# Crosstalk specification from Interference Tolerance

comment #105

Charles Moore: **SPG** Agilent Technologies

Brian Seemann: **Xilinx**

# Channel gain limit and Interference Tolerance limit for 10G BASE KR

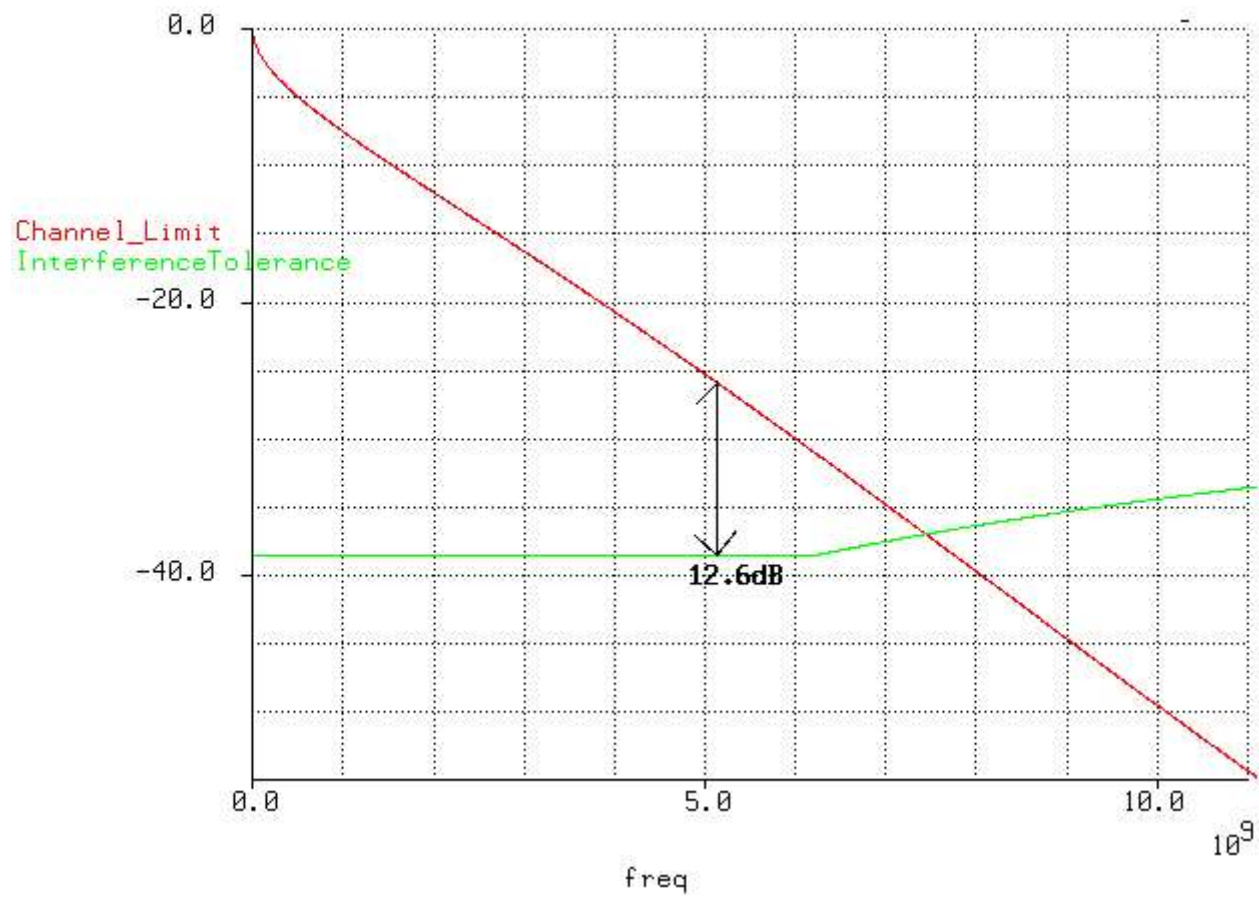
The Interference tolerance spec is flat over most of the frequency range. Measured interference tolerance tends to be flat as well. This indicates that Rx's are disrupted similarly by noise of the same energy level of different spectral types. For example, it seems reasonable to expect that broadband and sinusoidal noise of the same energy would disrupt the Rx the same.

Therefore I think that the total crosstalk spec should be flat. This ensures that the informative crosstalk spec allows the maximal possible crosstalk that the Rx can handle. In keeping with ACR approach, I suggest that the crosstalk spec be referred to the thru channel gain, specifically  $A(F_{\text{Nyquist}})$ , **the best linear fit to the channel gain, evaluated at half the data rate.**

In specifying crosstalk I want some margin to allow for thru channel reflection which will look somewhat like crosstalk and produce more stress than the presumably clean compliance channel used in interference tolerance testing. Therefore specify:

$$\text{PSXT} < -(A(\text{SignalSpeed}/2) + 16) \quad f < 0.6 * \text{SignalSpeed}$$

$$\text{PSXT} < -(A(\text{SignalSpeed}/2) + 16) + 20 * \log\left(\frac{f}{(0.6 * \text{SignalSpeed})}\right) \quad \text{SignalSpeed} > f > 0.6 * \text{SignalSpeed}$$

This Should replace 69.3.3.5.4 and may go into 69.3.3.5.3

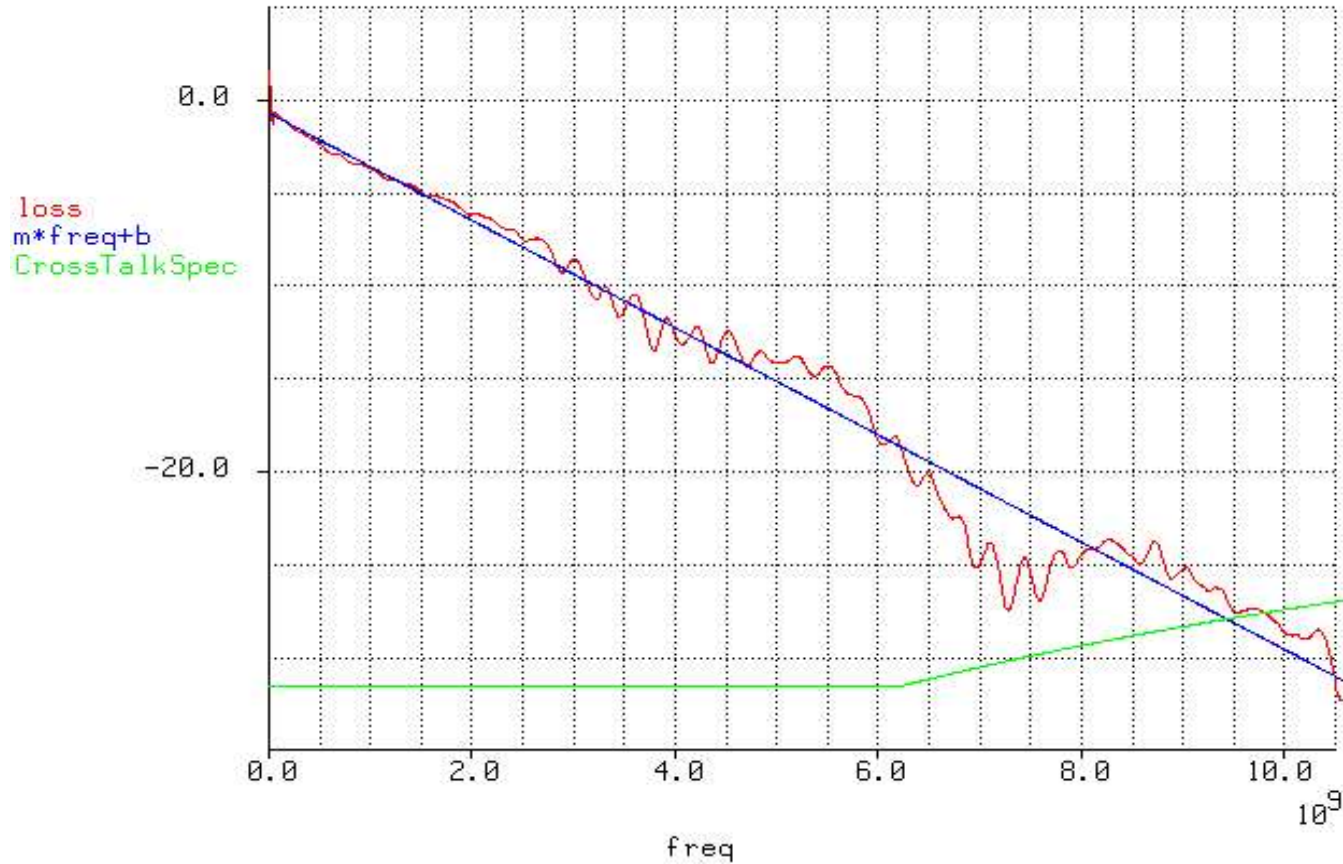
Q. Isn't 3.4dB excessive margin?

A. I do not think so. Unless we control Rx, Tx, and channel Return Loss, reflections may be a worse problem than crosstalk.

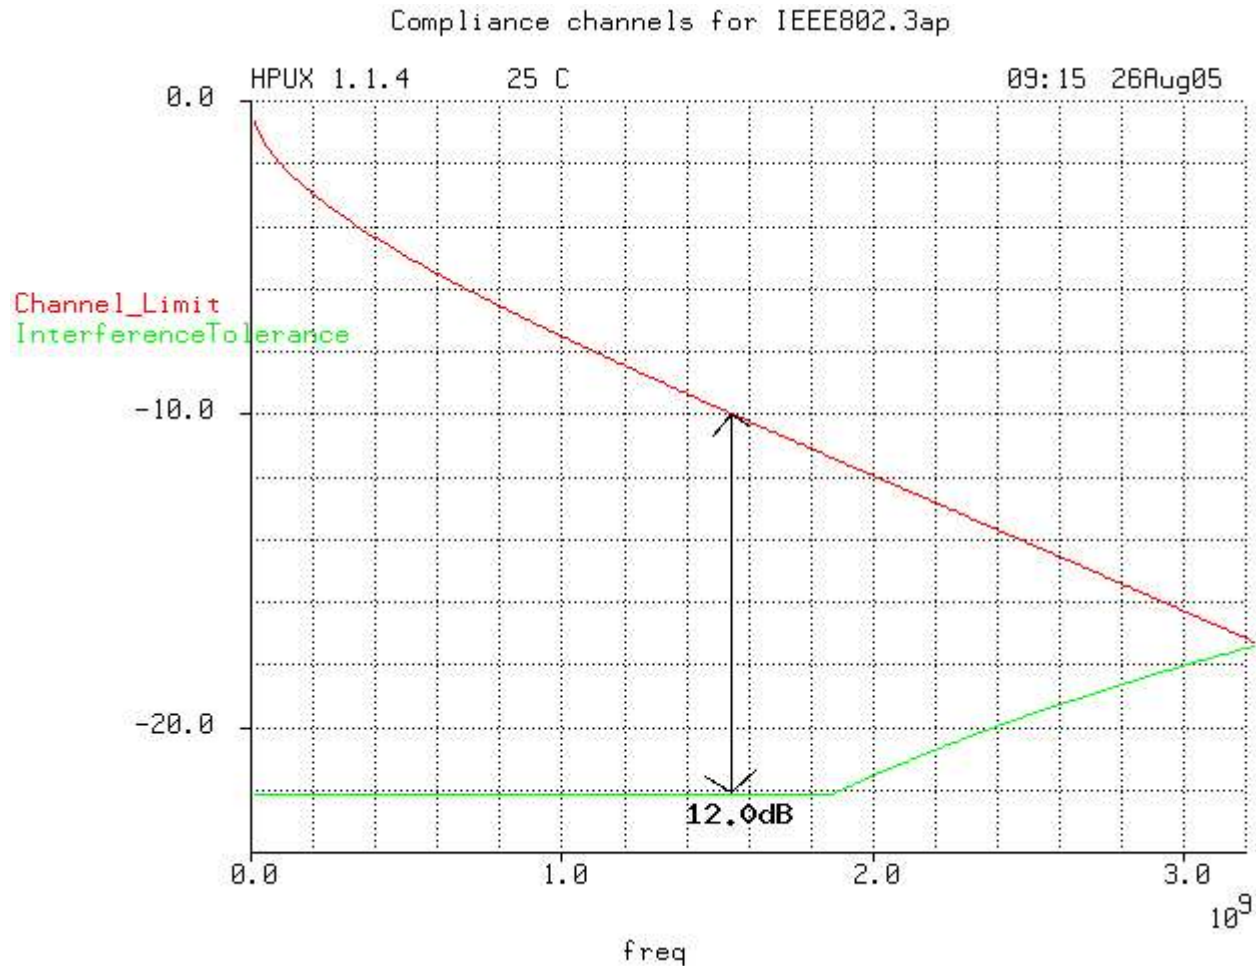
Q. Interference tolerance and using it to define crosstalk limit assume sinusoidal interference, but real crosstalk is noise-like, is this OK?

A. Well sort of. We assume that sinusoidal interference, which is always there, is a reasonable analog for a noise-like signal which has larger but rare peaks. This will be a useful approximation assuming

1. We use the correct ratio
2. The upper and lower boundaries of the Rx EYE are thick relative to the opening.

Below is a plot of the attenuation used in the test shown in sawyer\_10\_0905 and the fitting curve, with  $m=1.07$  and  $b=1.4$

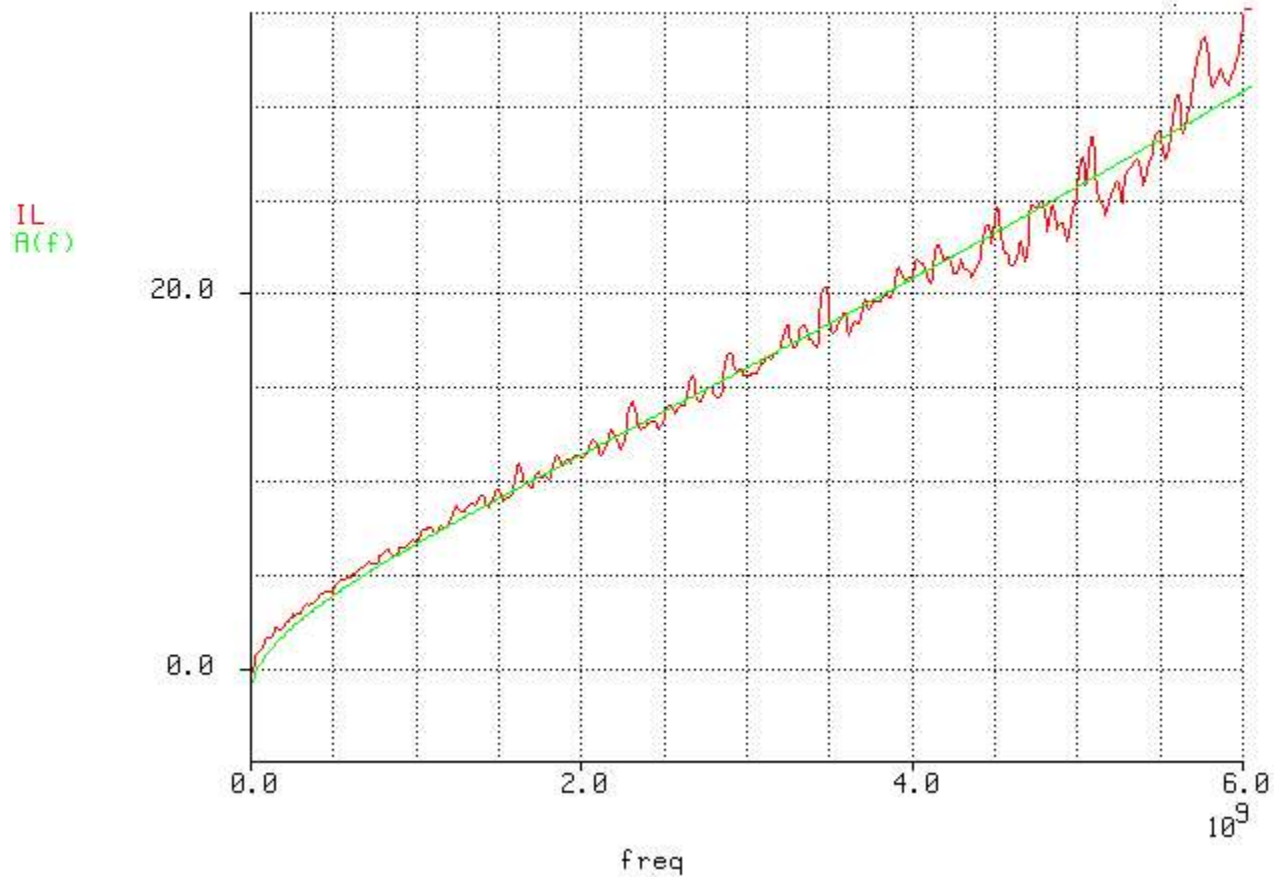
As defined the Compliance channel for Rx Interference tolerance testing may have to have excessive attenuation, significantly worse than worse case informative channel model, to get all ripple components below the spec line.

Solution: specify that a smoothed approximation to the attenuation be below the spec line ( $A_{\max}(f)$ )

If  $m \geq 1.0$  then the attenuation is generally greater than  $A_{\min}$  and the compliance channel meets spec. If  $b > 2$  and a transmitter, or instrument being used in lieu of a transmitter, is capable of it, the transmitter amplitude may be raised  $(b-2)$ dB above the maximum level which would otherwise be allowed, to compensate for excess DC loss in the compliance channel

If this specification is accepted, ISI loss becomes unnecessary and all references to it and min ISI loss (in Tables 70-8, 71-8 and 72-10) should be deleted.

# A 10GBASEKX4 transceiver EO = 12.0mV

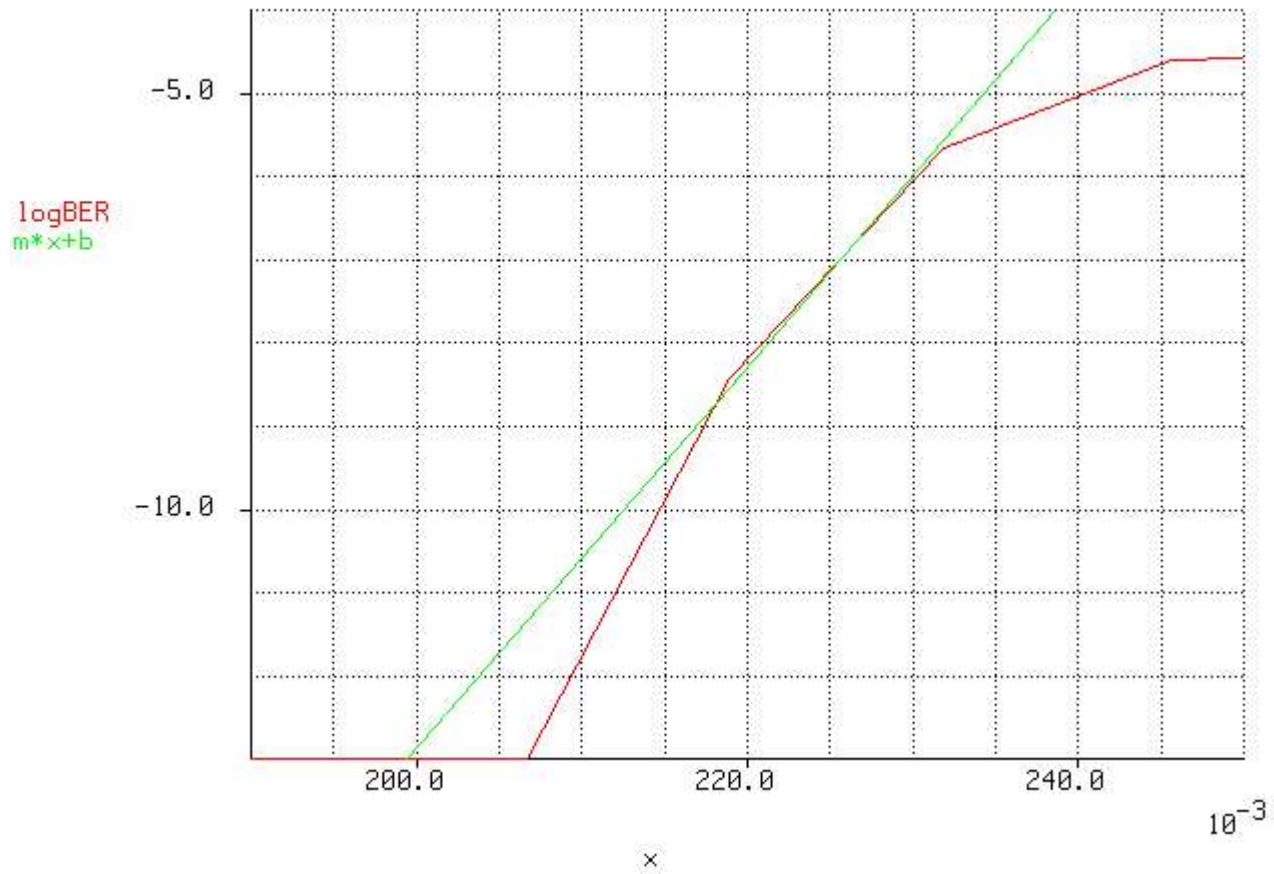
I have found in the limited number of cases I have looked at that the measured data from the amplitude sweep looks pretty good for extrapolation from about  $3 \times \text{Standard BER}$  to  $\text{BER} = 1e-6$ . The slide below show 3 cases of linear extrapolation in  $\log(\text{BER})$  using this range and LMS fitting.

Extrapolate the interference-BER data to a BER of  $10^{-12}$ . The difference between the interference at standard BER and the extrapolated value at  $10^{-12}$  is the extrapolation off-set (EO). The extrapolation can be done several ways. A suggested way is by a linear LMS fit to the data from a BER of 3\*standard BER to a BER of  $10^{-6}$ . Another way which is likely to give slightly more accurate and optimistic results is to use a quadratic LMS fit to the data from a BER of 3\*standard BER to a BER of  $10^{-6}$ .
